LAND -- ROVER

76/09/99/NAS

Front Seat Height Adjustment Binding

DISCOVERY Series II (LT)

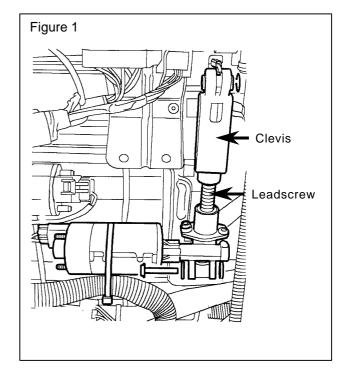
ELECTRIC FRONT SEAT HEIGHT ADJUSTMENT MECHANISM BINDS

Customers may experience front seats which do not work properly when attempting to change the height. This problem may be the result of ineffective lubrication on the raising mechanism which causes binding and possibly jamming at the end of travel.

- 1. Inspect lead screws for blue colored lubricant.
- 2. If blue colored grease is present, lubricating the lead screw and clevis will not improve the situation. The fault is elsewhere.

- 1. If blue grease is *not* observed, refer to the Workshop Manual Section 78.10.43.99 and remove the affected front seat.
- 2. Place the seat on a clean work surface.
- CAUTION: When cleaning and lubricating the seat mechanism, seat cushions and upholstery must be protected from lubricants.
- 3. Wipe both lead screws and plastic/metal clevis assemblies completely clean of all grease residues using a clean shop cloth.
- Lubricate each drive assembly with a 2cc (0.07 oz) bead of new blue lubricant (LRNR600D).
